Transmission Network Extension in North West Surat Basin Blythdale, Fairview and Fairview South Substations Project

**Transmission Network Extension in North West Surat Basin
Blythdale, Fairview and Fairview South Substations Project
Ministerial Designation of Land for Community Infrastructure
Comments on Draft Environmental Impact Statement (EIS)**

Review of the Draft Environmental Impact Statement (EIS) Ministerial Community Infrastructure designation for the Blythdale, Fairview and Fairview South Substations Project

Fairview Substation

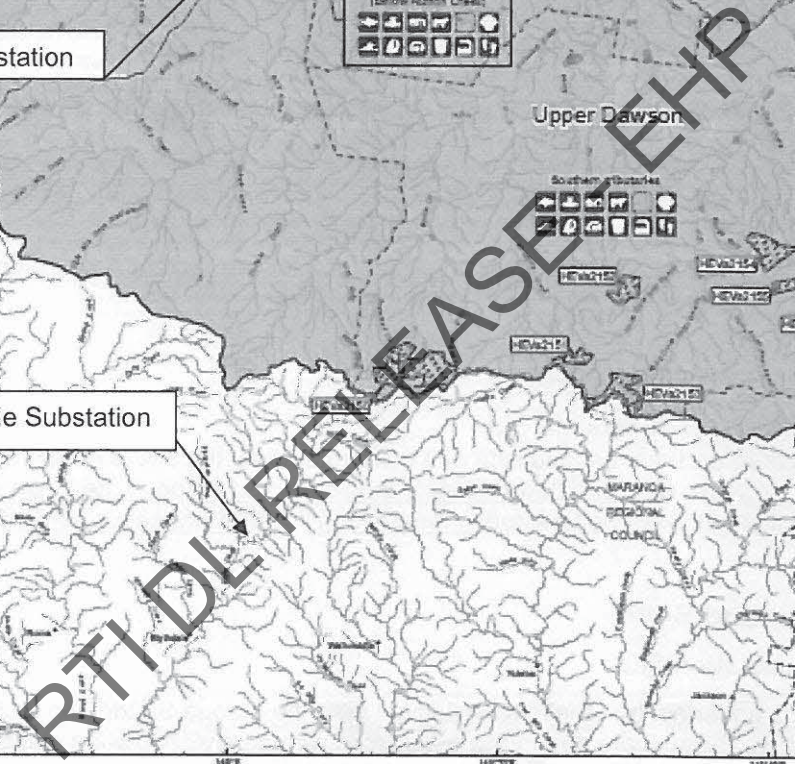
- The Fairview substation - is proposed for Lambing Gully (800m to the east) that drains to Baffle Creek (3.7km to the north) which forms the southern boundary to the western section of the Expedition (limited depth) National Park that is identified as HEV maintain (HEVm2141) on WQ1308 – Upper Dawson River Sub-basin Plan. Construction activities, if not managed appropriately could have to potential to impact on Baffle Creek (see Figure 1 below).

To assist in achieving the outcomes of the SPP 4/10, and ensure development undertaken as a result of community infrastructure development designations is planned, designed, constructed and operated to protect the water environmental values specified in the *Environmental Protection (Water) Policy 2009* the following conditions are recommended:

Condition 1 – Demonstrate compliance with SPP4/10

- Undertake construction activities in accordance with the "Appendix D Environmental Management Plan Blythdale, Fairview and Fairview South Substations Environmental Management Plan" (the EMP) of the document *"Powerlink Queensland Blythdale, Fairview and Fairview South Substations Draft Environmental Impact Statement November 2012* prepared by GHD for Powerlink or as modified for the final EIS.

- Where required by the EMP (e.g. Part 5.8 Erosion and sediment control), Erosion and Sediment Control Plans (ESCPs) are to be prepared by suitably qualified person as defined in the SPP 4/10 for Healthy Waters and are to be implemented under the supervision of suitable qualified persons as defined in the SPP 4/10 for Healthy Waters.

- In area of identified highly dispersive soils, the use of appropriately designed sediment detention basins must be included unless it can be demonstrated by a suitably qualified person, that discharge criteria can be met through alternative means.
